CITY OF ALBUQUERQUE

**RE: Air Quality Permit No. 3340-RMD ~ New Mexico Terminal Services, LLC
– Construction Permit – 9615 Broadway Blvd. SE**

ATTACHMENT
Public Participation Notification Letter
for New Mexico Terminal Services Permit Application #3340-RMD

Figure 1 – Map Showing All Bernalillo County Census Tracts with a Cancer Risk between 30 and 36 people in one million due to HAP

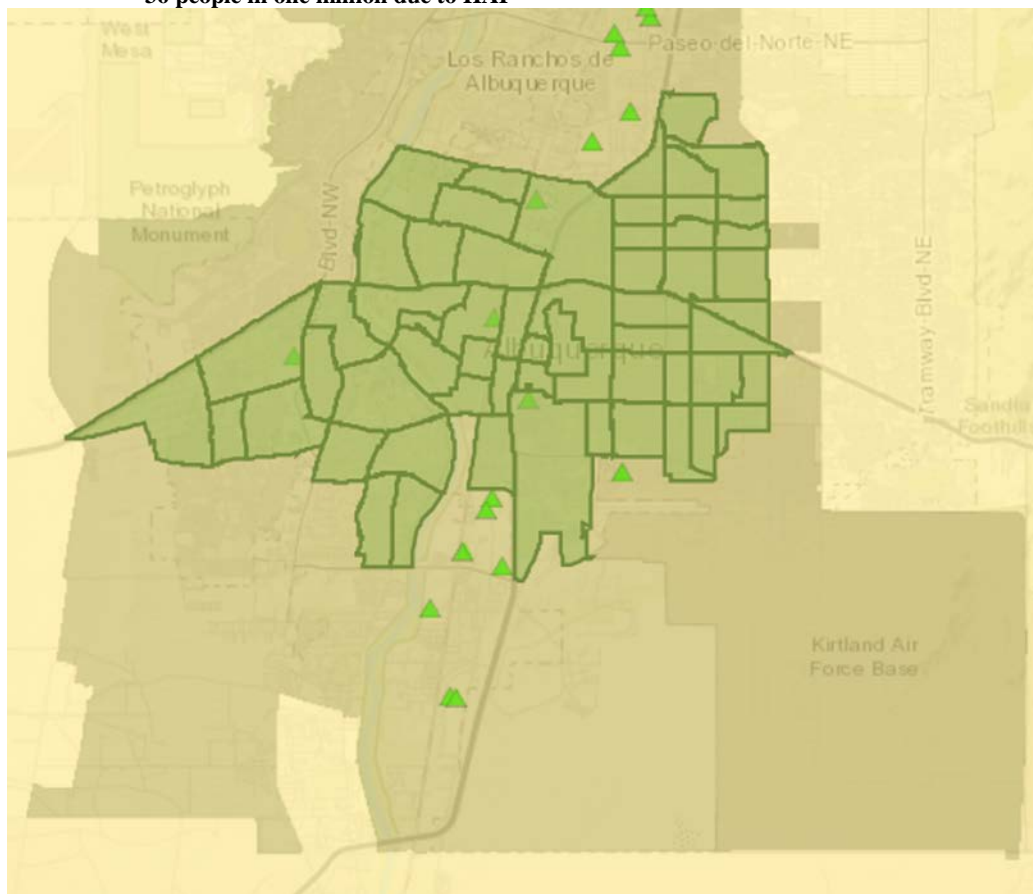
In any community, HAP may be emitted from a variety of sources, including mobile sources (cars, trains, planes, lawn mowers, construction equipment, etc.), stationary sources (government and industrial operations), individual residences (from heating and cooking activities), and natural sources (such as plants and trees). It is important to understand that even small sources (such as one's home or car) can attain significance when they are numerous. Any analysis of cumulative impacts must look at HAP from all of the above source categories, not one source category (such as stationary sources) in isolation. For Albuquerque-Bernalillo County, NATA indicates that cancer risks and non-cancer risks from HAP from stationary sources are well below levels, which would raise concerns about cumulative impacts.

The census tract where NMTS is located is in Mountain View. That census tract is not among the census tracts identified in Figure 1. The Mountain View census tract (Tract 4001) has a total cancer risk of 26 in one million. This is lower than the Bernalillo County average of 27 in one million and lower than the national average of 30 in one million. NATA is a screening cumulative risk assessment. The information in NATA does not raise concerns about cumulative impacts from HAP where the NMTS activity would be located.

Figure 2 – Map Showing All Bernalillo County Census Tracts with a Respiratory Hazard Index between 0.4 and 0.6.

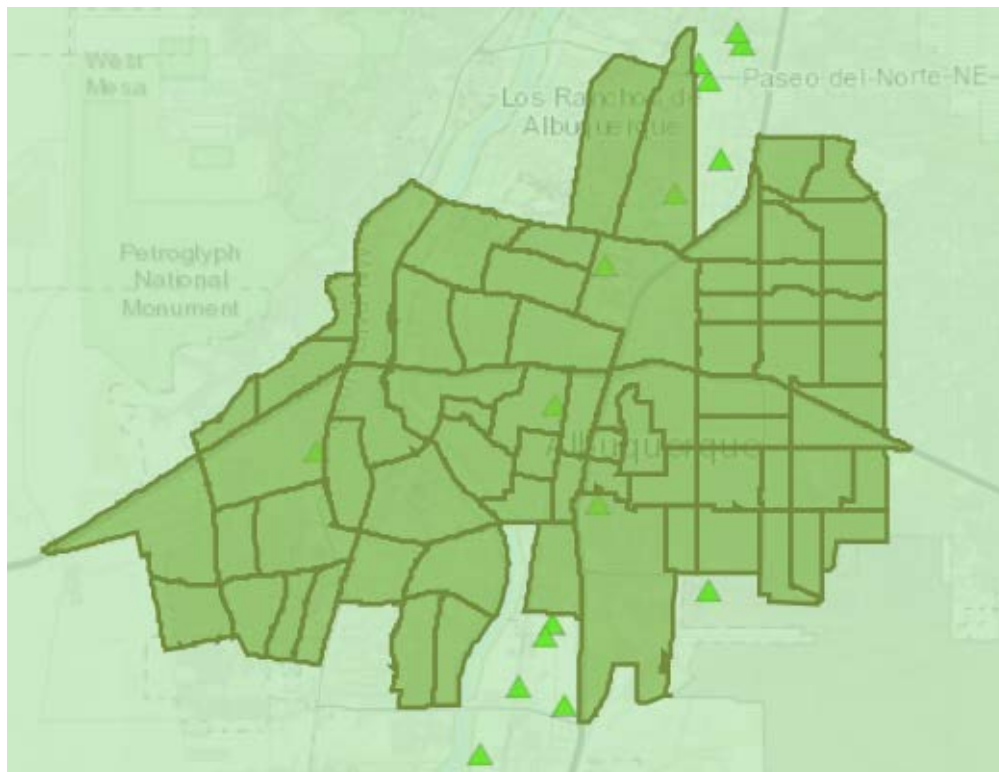
While all Albuquerque-Bernalillo County census tracts are below 1, the urban area has a higher respiratory hazard index than rural areas. Seventy census tracts (out of 159 total) located in the urban core of Bernalillo County have a respiratory hazard index between 0.4 and 0.6. These are higher than the county average but still well below 1. Those seventy urban census tracts are shown in Figure 2 below.

The census tract where NMTS is located is in Mountain View. That census tract is not among the urban census tracts identified in Figure 2. The Mountain View census tract (Tract 4001) has a respiratory hazard index of 0.35. This is lower than the Bernalillo County average of 0.37 and lower than the national average of 0.44. NATA is a screening cumulative risk assessment. The information in NATA does not raise concerns about cumulative impacts from HAP where the NMTS activity would be located.
